9-11-67

TO: Dr. E. L. Goldwasser and Dr. A. L. Read
FROM: W. W. Salsig
SUBJECT: Observations on Various Features of NAL Experimental Area
Proposals

FIG 3 COMMON SECTION - TWO WIDTHS

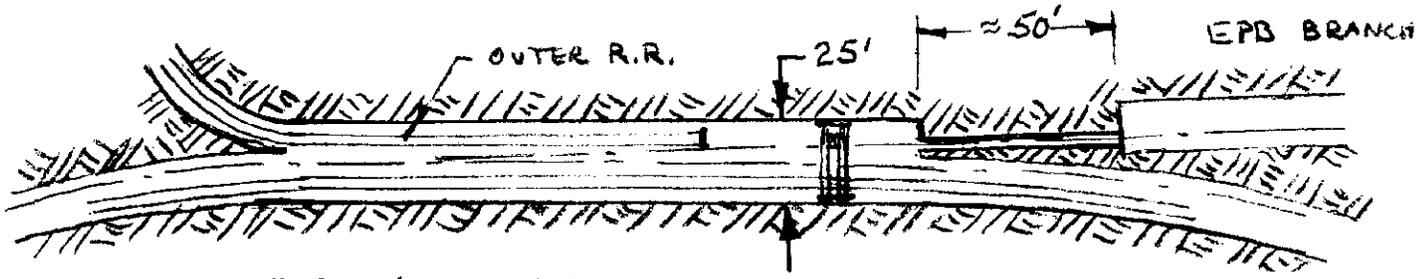
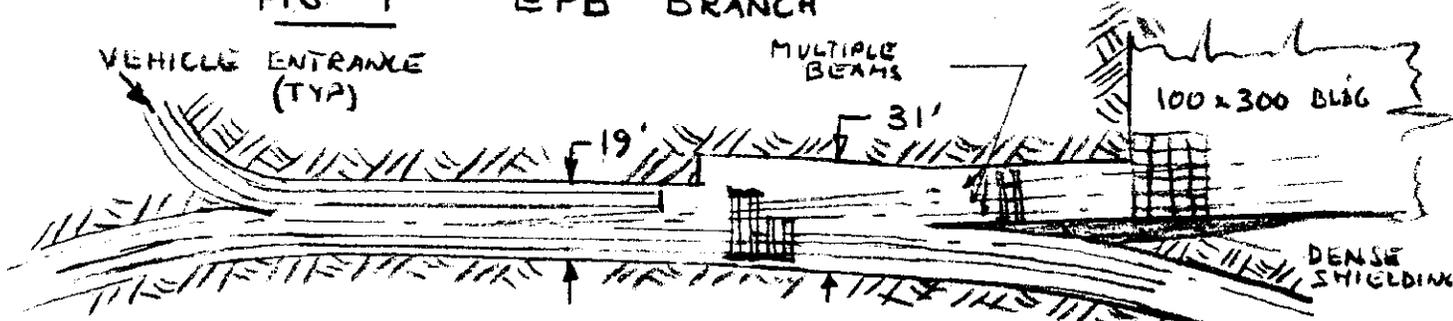
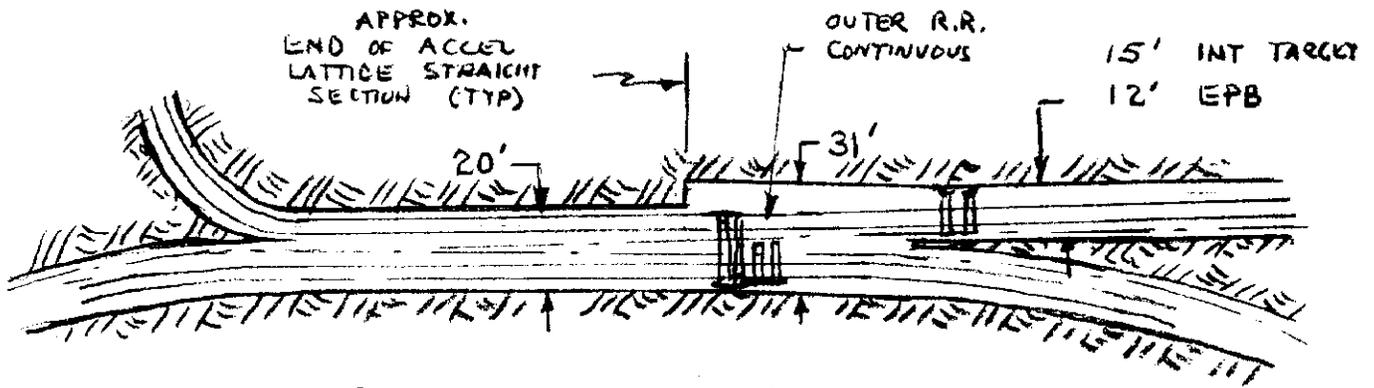
1) Can the two proposals for the EPB and the Internal Target and Construction Staging Area be made almost identical? In fact, can all of the 6 buildings over the long straight sections be made the same?

It appears to the author that they can be combined into a common structure style, as shown in Fig. 3, which increased the flexibility possible for the EPB exit. If the branch tunnel is made to junction with the main building, and the collimator effect obtained by an arrangement made such as shown in Fig. 5, (instead of earth fill around a small pipe as in Fig. 1), one has future flexibility. If, several years after starting, it is desirable to put different beam transport elements in, they can go anywhere and the tunnel plug can also be repositioned. A further advantage is that the outside radius railroad can be made continuous down the EPB tunnel.

Costs for implementing Fig. 3 in place of Fig. 1 and Fig. 2 would be little changed.

FIG 4 COMMON SECTION - TAPERED EXPANSION
(J. MACDONALD - DUSAF)

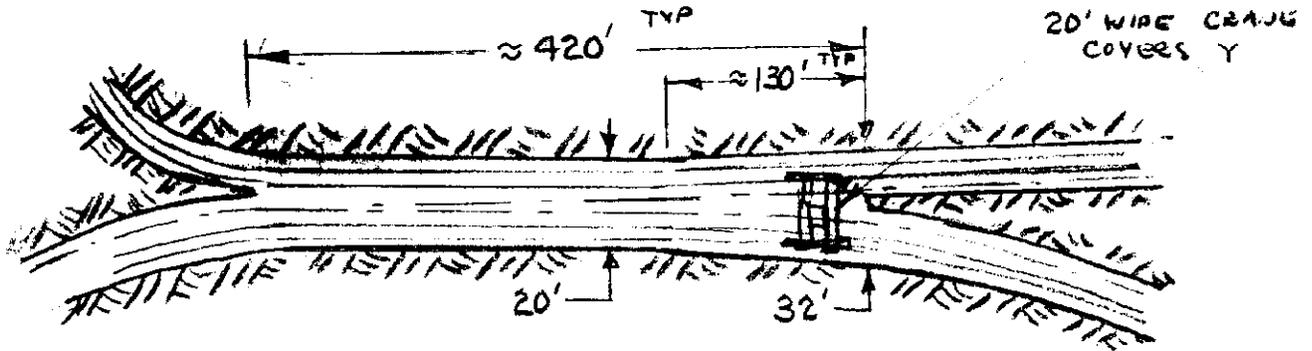
A further interesting scheme was shown to me by MacRonald of DUSAF just before I left, as shown in Fig. 4. This envisions a tapering widening of the last 120 ft of the long straight section, instead of the abrupt widening of Fig. 3. Both outside and inside radius railroads are identical with Fig. 3. The one 20 ft wide crane services the Y area quite well and a branch crane from the internal target tunnel can be interlaced with the main building crane if it is the underhung style, but without the trolley transfer feature. This scheme reduces the main building floor area from 10,500 ft² scheme in Fig. 1 to approximately 9,100 ft², for additional cost reductions of approximately 900 x \$28 = \$25,000 per station over Fig. 3 scheme

The choice for scheme 4 (Fig. 4) rests on DUSAF'S ability to economically make cross-beams of many different lengths, compared to just two for Fig. 3, and the value the operating people would place on the usefulness of an inside storage alcove with crane coverage which comes as a byproduct of Fig. 3.

FIG 6 TEMPORARY COLUMNS TO ALLOW INITIALLY
LIGHTER CONSTRUCTION IN UNUSED STRAIGHT SECTIONS

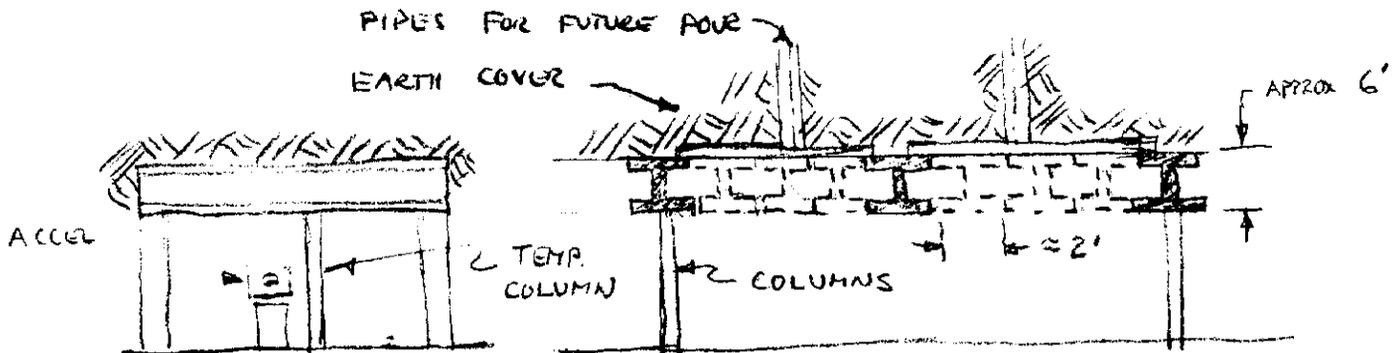
Before leaving the discussion of the long straight section buildings, a wild idea should be mentioned with respect to the initially "unused" ones -- will there be 3? If some scheme could be found which would cut down the initial cost, and the full building be recovered by future cost at a time when it was needed, without massive reconstruction, the savings might be attractive. If columns are allowed at

midspan on the roof support beams, the span is halved and the stress reduced a factor of approximately 4. So, perhaps only each 4th beam needs to be used. Spanning panels overhead would support the earth.

When the unobstructed area needs to be recovered, the space between the beams could perhaps be poured with concrete from previously placed pipes, and the columns could then be removed. Some equivalent scheme could be postulated for the floor.

The important feature is that columns, which might not be much of an impediment when buildings are "in reserve", would greatly reduce the job required of the overhead and floor beams or slabs. This scheme has been roughly outlined to Ross Dowdy, DUSAF Structural Engineer, who got a gleam in his eye but said little more than "people are always trying to make life harder for the Structural Engineer". Perhaps he should be encouraged to think about such a scheme on his own terms.

FIG 7 RAIL SERVICE FOR EPB BRANCH LINES

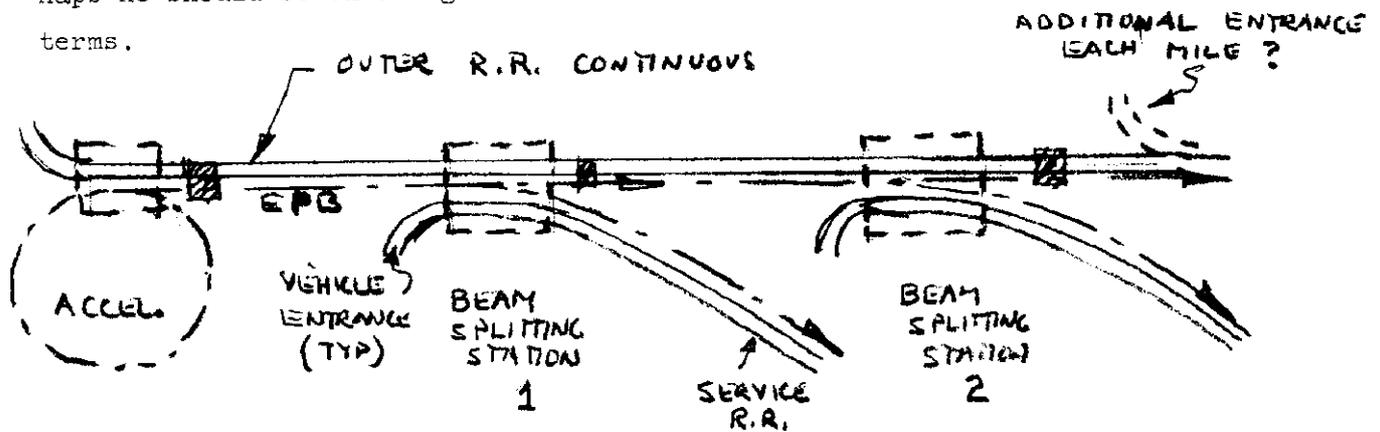
With main building arrangements as suggested, the service railroad down the outside of the long EPB could be continuous. Branch lines could be introduced at each beam splitting station on the "inside radius", so that each splitting Y would have some servicing capability as Main Ring Buildings.

At Target Stations on the split branch line the scheme would be opposite hand.

FIG 8 - REDUCTION IN BRANCH TUNNEL LENGTH BY USE OF HEAVY AGGREGATE TO SHIELD FUTURE CONSTRUCTION SITE

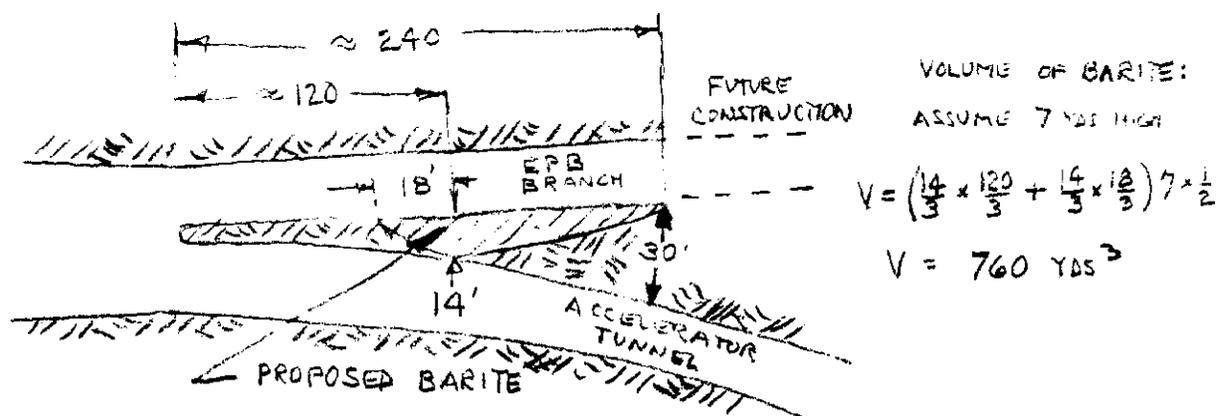
If heavy aggregate, for example barite at 220 lbs/ft³, were used between the accelerator and branch tunnels, the branch tunnel length could be decreased to approximately 120 ft in length which would reduce costs \$40,000. However, with barite aggregate installed

7 yards high, 760 yards³ would be required which is \$84,000 at \$110/yard³ in place. This certainly is far from a net savings in initial cost, even though the barite, worth approximately \$95/yard³, might be usefully salvaged after the tunnel extension.
